**Finding of No Significant Impact
Cuyahoga River Ecosystem Restoration
Canal Diversion Dam Project
Environmental Assessment**

***RE: Comments in Response to the Cuyahoga River Ecosystem Restoration Canal
Diversion Dam Project Environmental Assessment***

USEPA and USCOE comments and response – United States Environmental Protection Agency (September 28, 2016) and United States Army Corps of Engineers, Regulatory Branch (October 7, 2016) reviews.

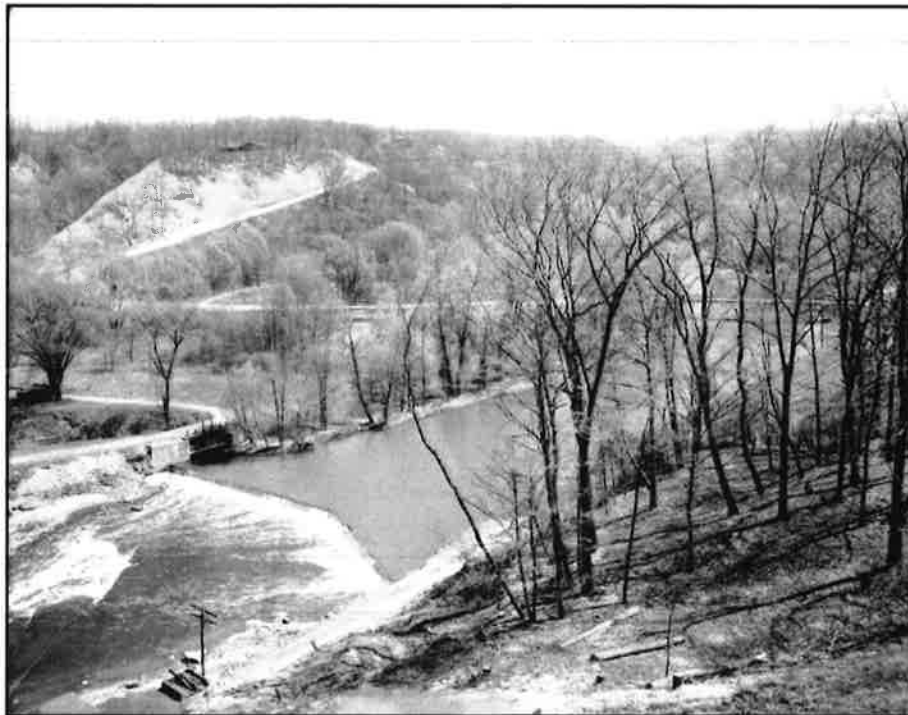
There were several comments related to project implementation. These included project sequencing and project staging locations. Comments indicated that these items were not discussed in adequate detail.

This EA is a planning document designed to assess and evaluate the project in relation to resources within the Cuyahoga Valley National Park. The EA is not a design and or construction plan nor is it a permit application. The restoration project will be proposed to accept bids from qualified professionals capable of performing the work. The preferred method for the project will be a design/build process as our local experience has found this works well for these types of restoration projects. We will specify in the request for proposals that our goal is to minimize and avoid if possible additional natural resource impacts, and any action beyond the scope of the selected alternative will developed through the NPS environmental process. Allowing professional stream restoration practitioners to submit bids based on their experience and interpretation of existing conditions will result in a more robust process, free from any limitations resulting from the EA. All bids will be reviewed and a contract awarded to the proposal which best meets the project goals. Minimizing any and all impacts will be a goal and is best addressed through the actual design/build project process. The comments have been adequately addressed in the EA, no changes are needed.

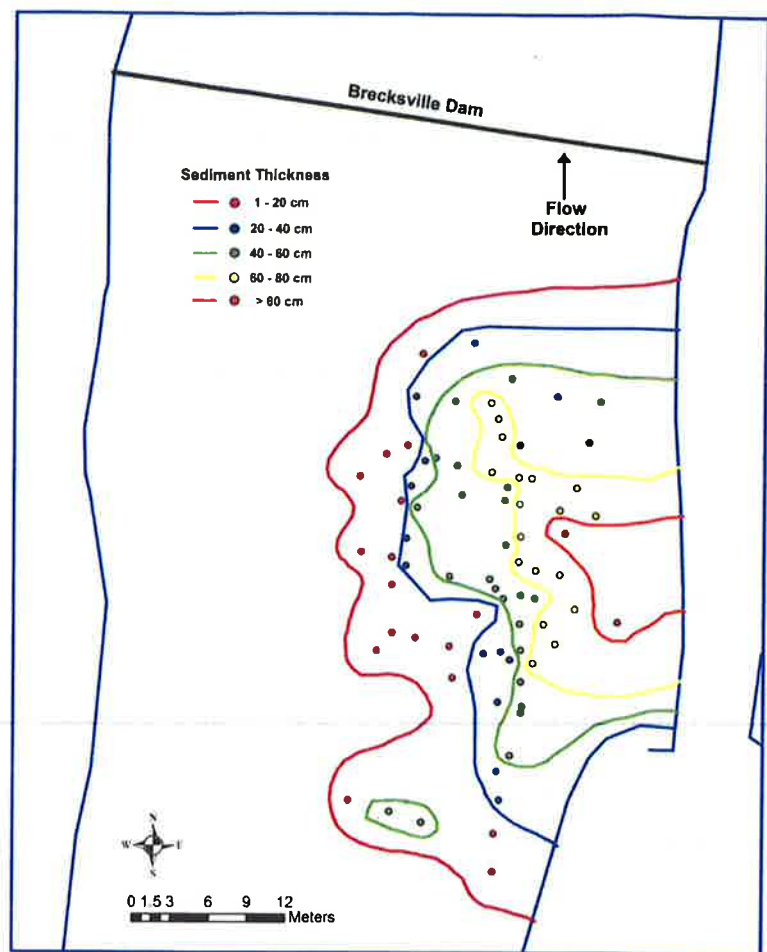
There were several comments received related to sediment accumulated in the dam pool. One group of comments was about the chemical composition of the sediment accumulated behind dam pool; other comments concerned the volume of the sediment accumulated behind the dam. Two responses are given below: Response 1 addresses the questions of sediment composition and Response 2 addresses the question of sediment volume.

Alternative 3 (proposed action) involves removal of the dam and restoration of natural bedload transport within the Cuyahoga River. No sediment removal is proposed for the project. Section 4.2.3.2 of the EA was expanded to include additional discussion related to sediment transport. This additional discussion includes an analysis of suspended sediment loads in the Cuyahoga River. The analysis is consistent with predicted beneficial outcomes related to the Cuyahoga River following dam removal.

Sediment thickness in the dam pool was evaluated as part of a 2010 study (Peck 2010) utilizing ground penetrating radar to delineate the Pinery Dam. Sediment thickness is depicted in the diagram to the right, taken from the Ground Penetrating Radar Survey Report mentioned above. The thickest sediment is located near the intake gates for the Ohio and Erie Canal. Based on the information provided in the 2010 study, a volume of 521.5 m³ can be conservatively calculated within the lower section of the dam pool. This can also be expressed as 682 cubic yards or approximately 947 tons.
